REMARKS

Description of the Invention

FIG. 5C

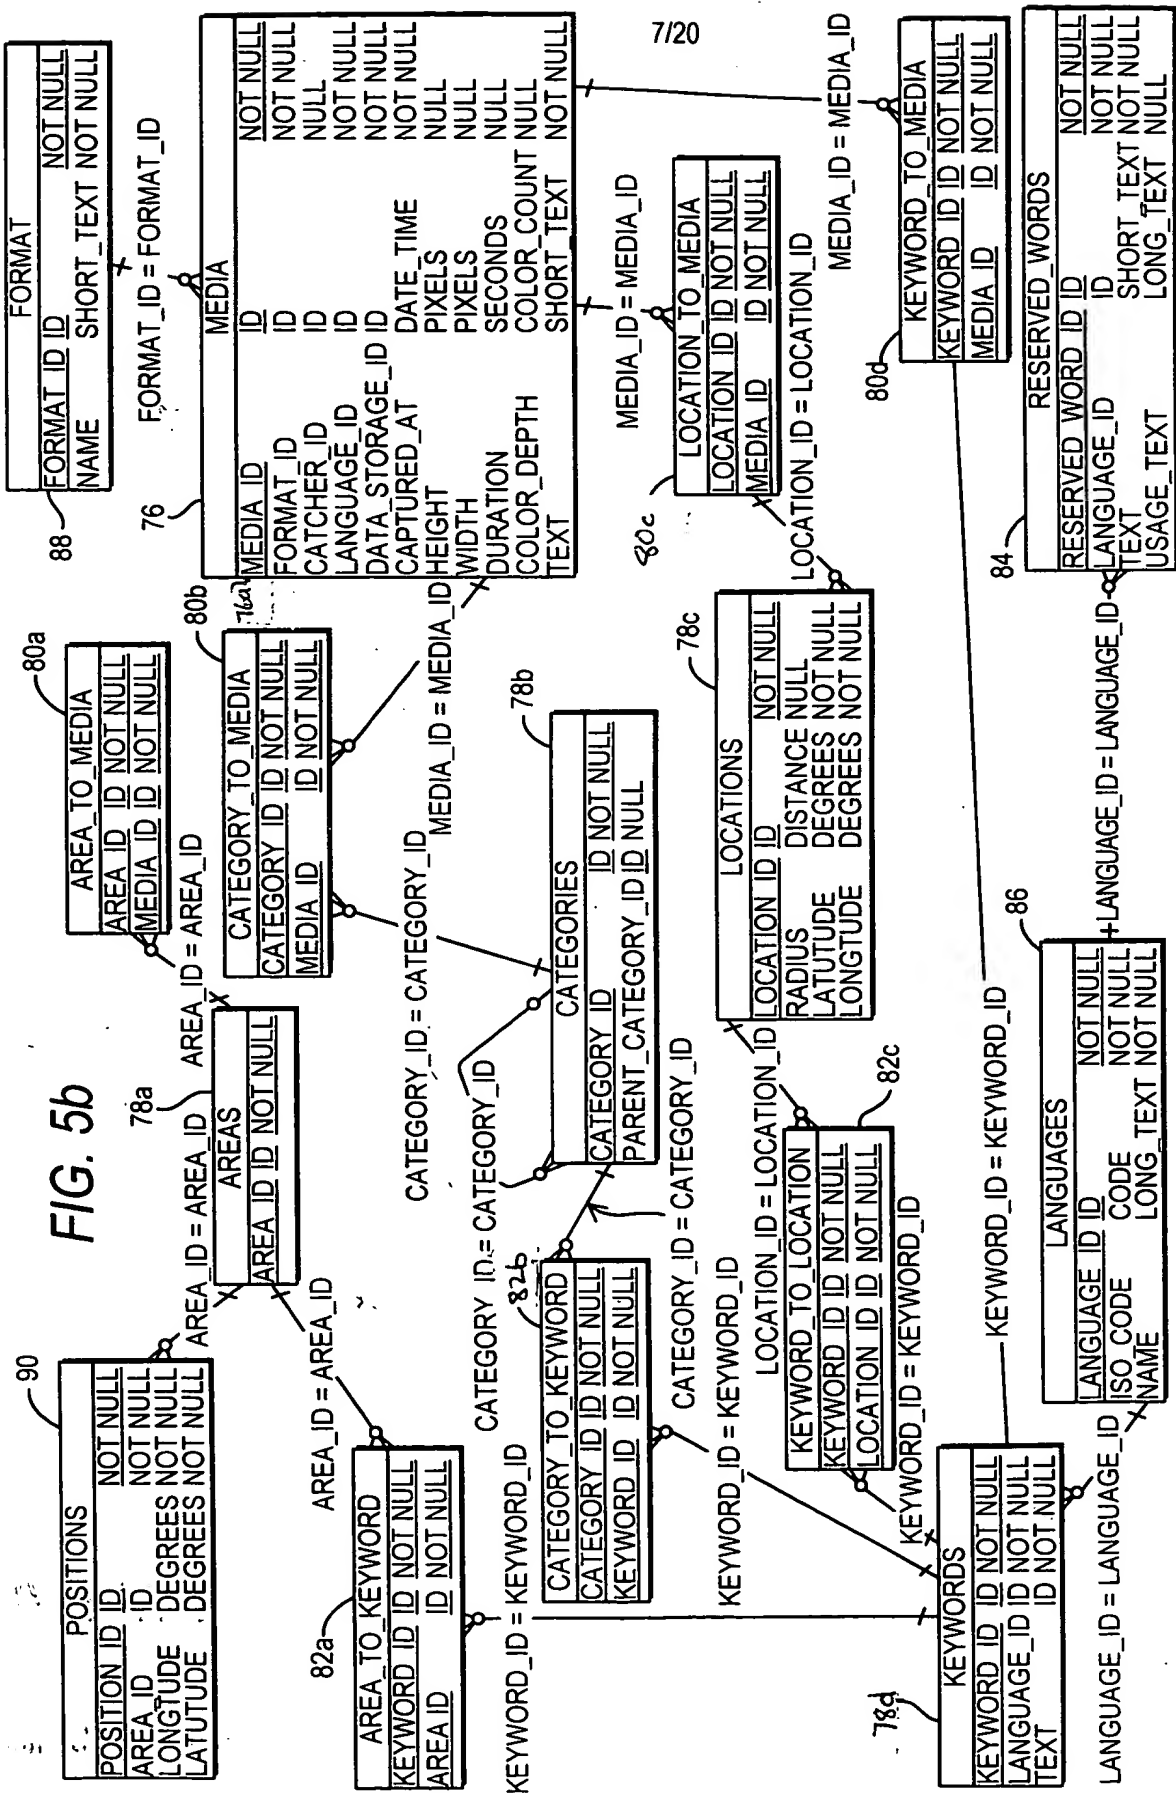
Attached are copies of two sheets of drawings. Proposed corrections to Figures 5b and 5c, shown in red, do not constitute new matter. Applicant requests that the Examiner approve the proposed corrections. After official communication of such approval, Applicant will make the appropriate corrections to the formal drawings.
